GLIDING FEDERATION OF AUSTRALIA

AIRWORTHINESS DIRECTIVE GLIDERS:

REFERENCE No. GFA/AD 197 GROB 18

GLIDER TYPE AFFECTED: Grob Speed Astir 11 and 11B, from serial number 4001

Technische Mitteilung
TM 320-3

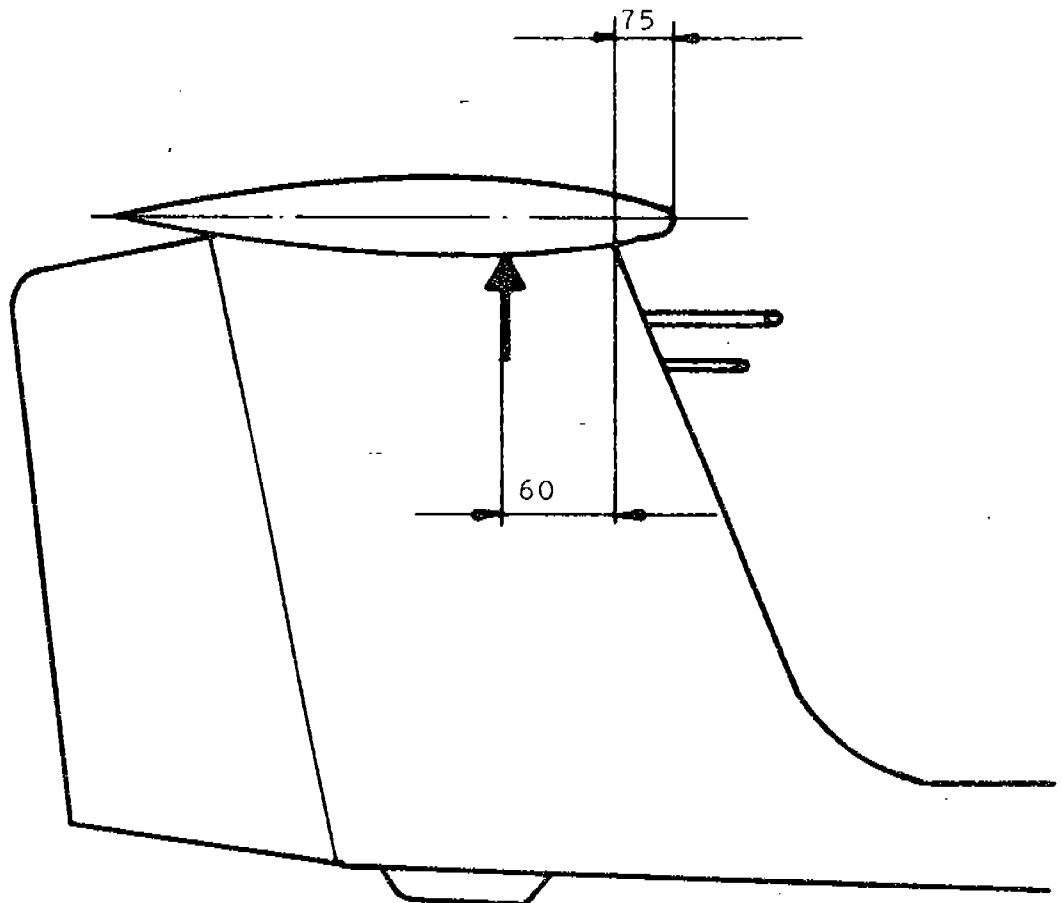
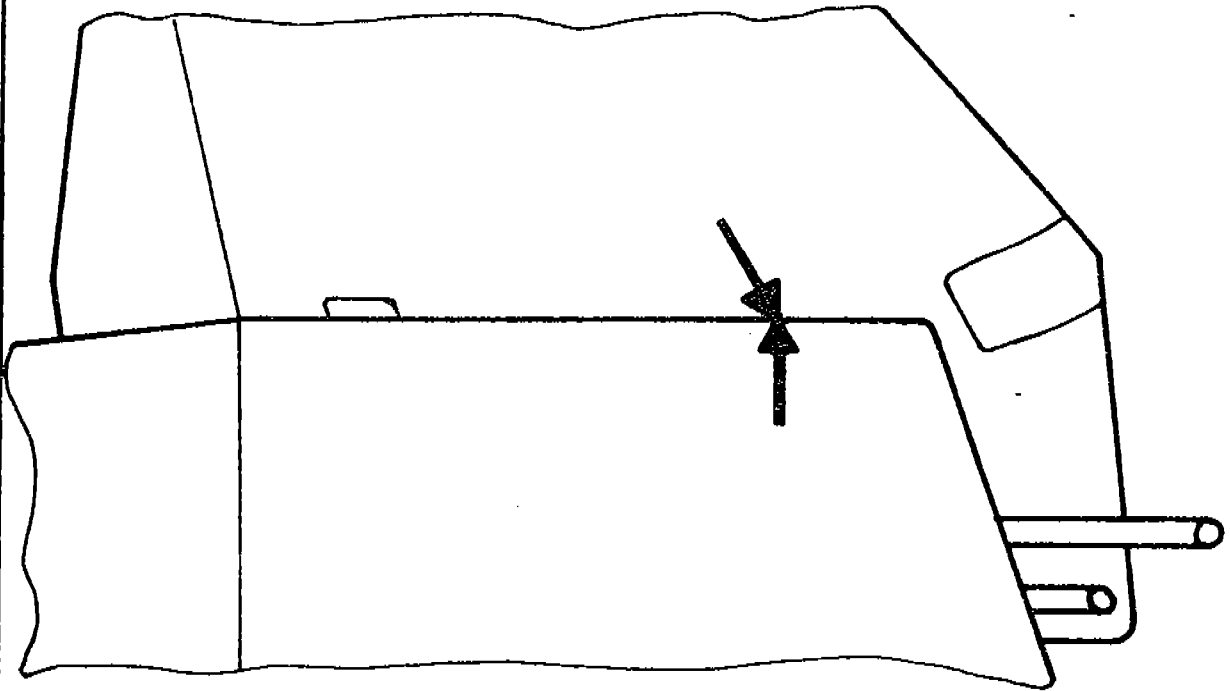
- (b) Provided the 4 markings at elevator and fin are still existing they must coincide after correct mounting. The former poorly adherent markings should be removed and replaced by new ones at the same position.

- (c) Provided the 4 markings at elevator and fin are missing completely or partially, the rest of the previous marks should be removed and replaced by new markings according to construction drawing. Before applying glue make sure the region is free of oil, grease or residue of former labels.

- (d) To attach the new marks, it is necessary to remove the paper cover before rubbing the arrow firmly with the transparent foil. Then the foil should be carefully removed and the mark again pressed. After 24 hours the adherence is sufficient to withstand application of sealing tape between stabilizer and rudder. There is no risk to remove the marking inadvertently when removing the tape.
